Access Compliance Report Public Rights-of-Way (Curb Ramps)

Main Street: **NARROW_CANYON_RD** Cross Street: **NARROW_CANYON_RD** Location: **N**

ADA ID: **RPRK211103162852** Ramp Type: **Type 1 - Perpendicular** Initial Pass/Fail: **Fail** Overall Compliance: **No** Severity Score: **16**

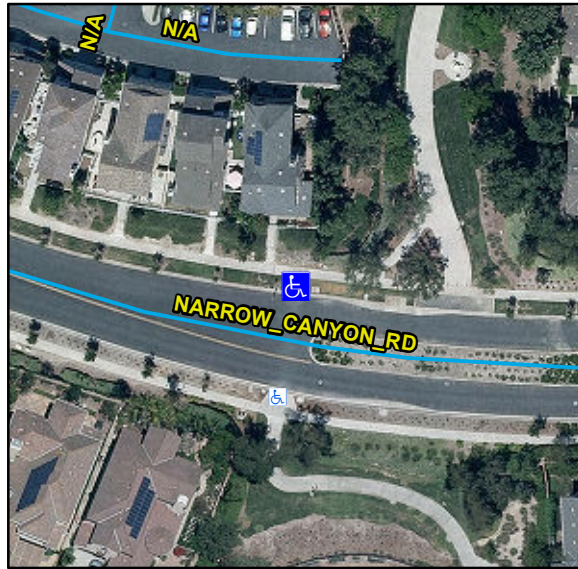
Compliance	Description	Data	Compliance	Description	Data
N/A	Ramp Length (in)	90	N/A	Flare Type LT	
Yes	Ramp Width (in)	54			N/A
No	Ramp Run Slope (%)	10	N/A	Flare Slope LT (%)	N/A
Yes	Ramp Cross Slope (%)	0.5	N/A	Flare Traversable LT	N/A
N/A	Landing Present	N/A	N/A	Flare Type RT	
N/A	Landing Length (in)	N/A			N/A
N/A	Landing Width (in)	N/A	N/A	Flare Slope RT (%)	N/A
N/A	Landing Run Slope (%)	N/A	N/A	Flare Traversable RT	N/A
N/A	Landing Cross Slope (%)	N/A	N/A	DWS Provided	N/A
N/A	Landing Movement Obstructed?	N/A	N/A	DWS Contrast	N/A
	Landing Movement Type	N/A	N/A	DWS Length (in)	N/A
N/A	Landing Shared	N/A	N/A	DWS Full Width	N/A
N/A	Clear Space	N/A	N/A	DWS Offset Left (in)	N/A
N/A	Clear Space To Crosswalk (in)	N/A	N/A	DWS Offset Right (in)	N/A
N/A	Marked Crosswalk 1	No	N/A	Marked Crosswalk 2	N/A
	Crossing 1 Direction	S		Crossing 2 Direction	N/A
	Marked Crosswalk 1 Width (in)	N/A		Marked Crosswalk 2 Width (in)	N/A

N/A	Ramp Inside Crosswalk 1	N/A	Yes	Ramp Inside Crosswalk 2	N/A
	Crossing 1 Slope (%)	2.9		Crossing 2 Slope (%)	N/A
	Crossing 1 Cross Slope (%)	0.3		Crossing 2 Cross Slope (%)	N/A
N/A	Gutter Ponding	N/A	No	Curb Slope	11.5
Yes	Gutter Lip Height (in)	0		Road Run Slope (%)	N/A
N/A	Gutter Run Slope (%)	N/A		Road Cross Slope (%)	N/A
N/A	Gutter Cross Slope (%)	N/A			
Yes	Overall Surface Condition: Acceptable		No	Perp Joint Present	No
	Cross Gutter Present?	No		Spandrel Present?	No
	Replace Cross Gutter?	N/A		Replace Spandrel?	N/A

Remove & Replace Entire Ramp.

R304.2.2, R204.3, STD 1115
